#2013-61
Martin Chevrolet – Special Use Permit Amendment
Project Review for Planning and Zoning Commission

Meeting Dates:	September 2, 2015
Requests:	Review of the site lighting as a condition of the previously-approved Special Use Permit Amendment and a Variation from the requirements for light levels.
Location:	5220 Northwest Highway
Acreage:	8.8 acres
Existing Zoning:	"B-2" General Commercial
Surrounding Properties:	North: "M" Manufacturing South: "B-2" General Commercial East: "M" Manufacturing and "B-2" General Commercial West: "B-2 PUD" General Commercial PUD
Staff Contact:	James Richter II (815-356-3737)

DRAWING NO.
E-1P

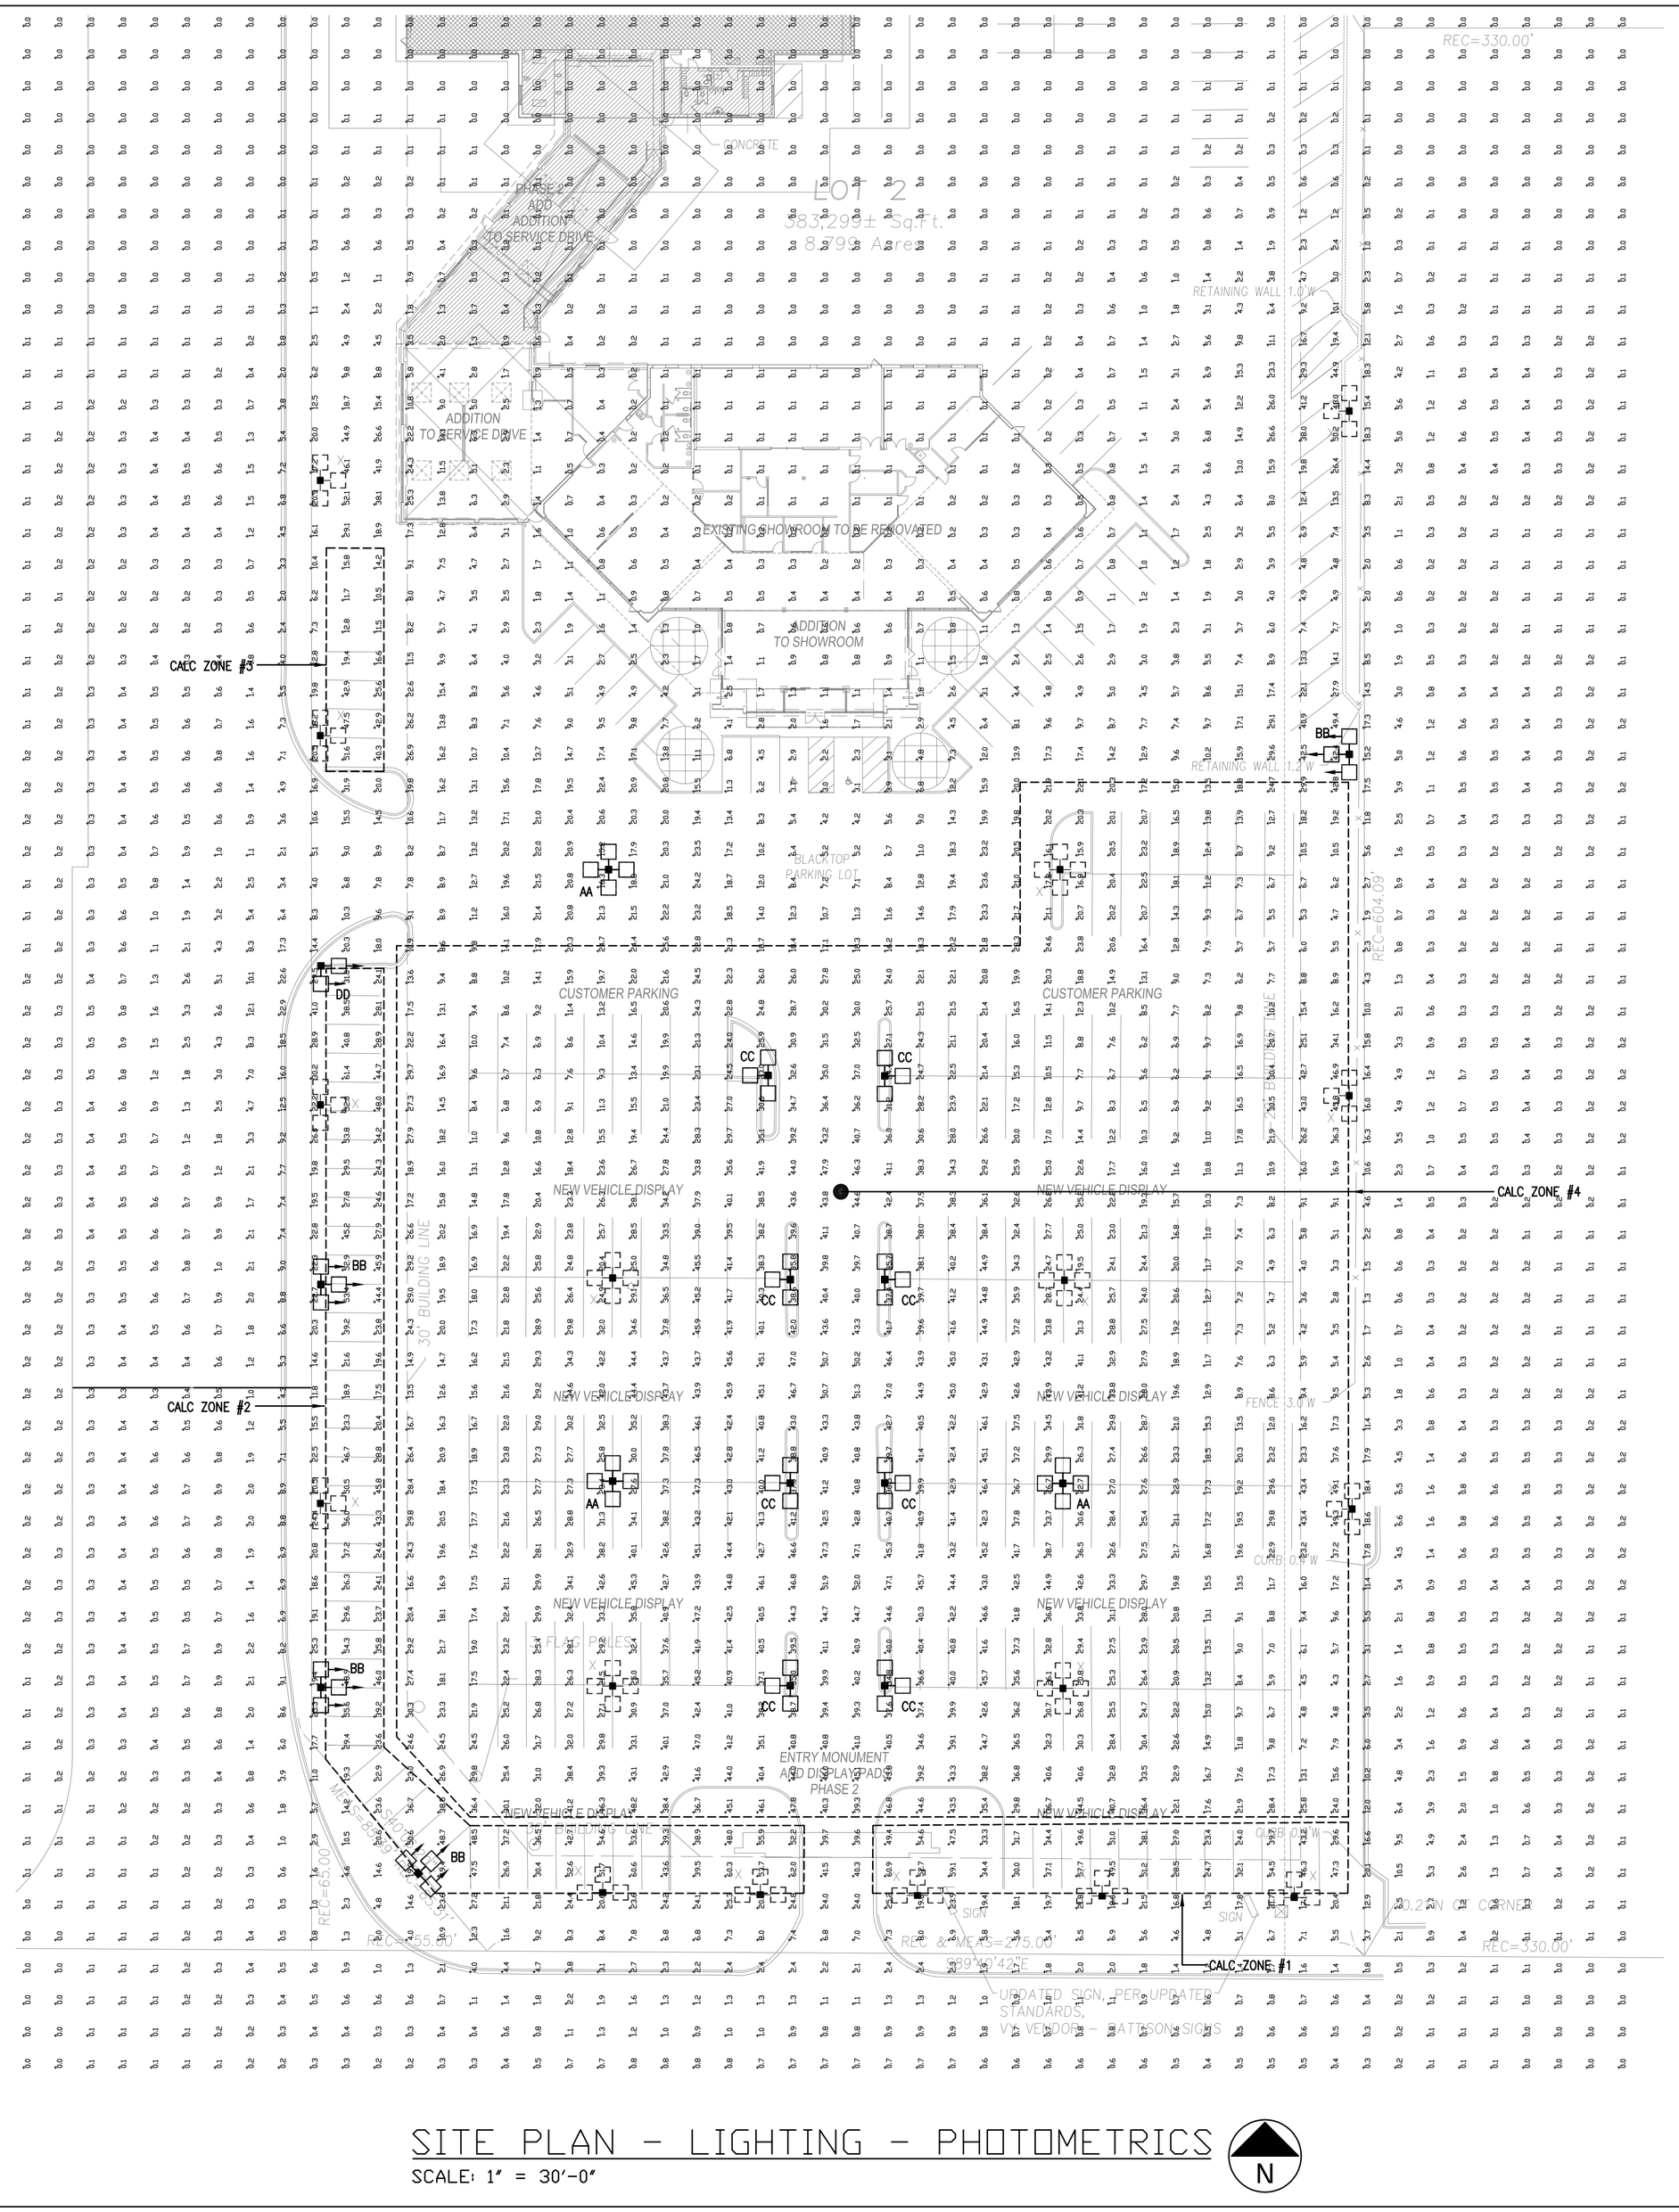
Site lighting: The overall site lighting is the only item under review. The site is held to overall illumination levels that have been implemented by the UDO for auto dealerships. The proposed lighting standards can be as tall as 35 feet, by Ordinance. The petitioner's light poles do not exceed 25 feet in height, thereby keeping the lighting closer to the ground, which prevents the spread of light pollution. The UDO requirement for lighting intensity is 20 maximum average footcandles (fc) for front row display and 10 maximum average fc for the remaining display areas. The plan shows up to 61 fc for the front row (average 41 fc) and an average of 25-41 fc for the other areas. This correlates almost exactly to what Pauly Toyota and Anderson Motors have on their site.

b. Lighting: All lighting shall be designed and installed to prevent glare or excessive light spillover onto adjacent properties, in accordance with the requirements of Article 4-800, Exterior Lighting Standards.
   The petitioner's site lighting plans do not meet the requirements of the UDO for maximum intensity, average intensity, and pole height, however, they are generally consistent with previously-approved auto dealerships through the City.

1. Approved plans, reflecting staff and advisory board recommendations, as approved by the City Council:
   A. Application, Martin Chevrolet, received 1-9-14
   B. Site Lighting Plan, Hansen Palmer and Associates, revised 8-19-15.

2. All lighting fixtures shall be directed downward. During the inspection process, staff reserves the right to require shielding and other intensity adjustments to minimize glare on adjacent properties.
